WOLF CREEK NUCLEAR OPERATING CORPORATION

ET 18-0035

Subject: Docket No. 50-482: Supplemental Response to RAI for License Amendment Request to Revise Technical Specifications to Transition to Westinghouse Core Design and Safety Analysis Including Adoption of Alternative Source Term

Supplemental Response to Request for Additional Information

Figure 1: Control Room and Control Building Ventilation Flows

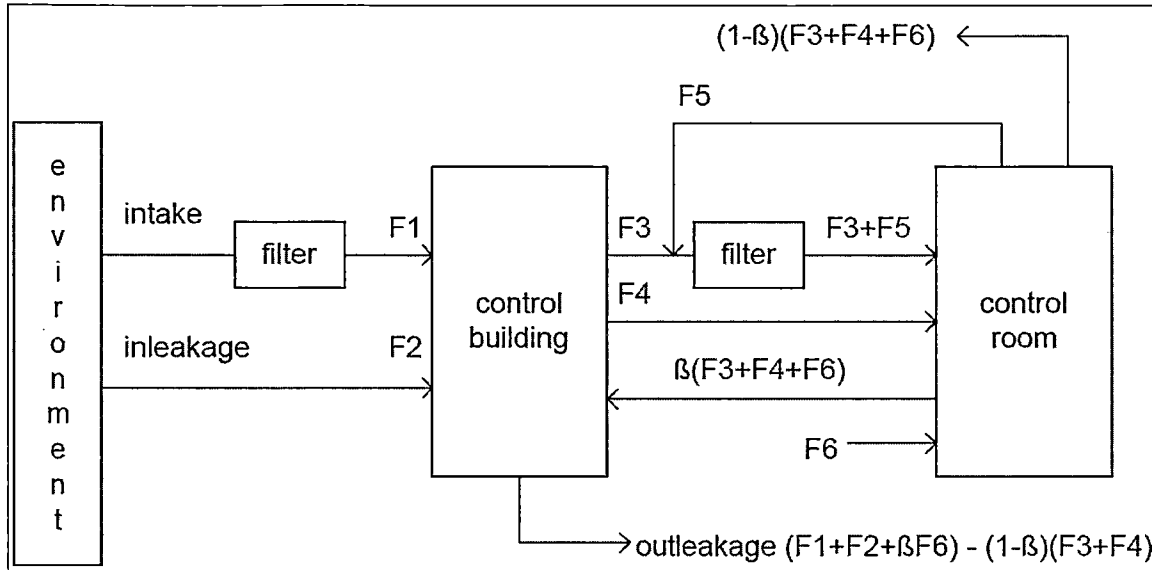
Also, please confirm the value of 300 cfm of filtered forced air flow from the equipment room to the control room during the emergency mode (or provide the value assumed) and justify the value assumed.

ARCB1-FHA-5 and ARCB1-FHA-6: The equipment room and associated HVAC flows were added to the model.

The HVAC flows are illustrated in Figure 1 with flowrates described in Table 4:

Flow Path	Normal Mode Flow (cfm)	Emergency Mode Flow Prior to Operator Action (cfm)	Emergency Mode Flow After Operator Action (cfm)
F1	0	1350	675
F2	14360*	400	400
F3	0	550	550
F4	0	550	0
F5	0	1250	1250
F6	2195**	50***	50***
β	0	0	0

*** After Normal HVAC intake closure: 10 cfm via communications corridor associated with ingress/egress plus 40 cfm via Emergency HVAC intake. For the FHA auxiliary building release case, the 50 cfm comes from the Equipment Room; see the response to ARCB1-FHA-5.
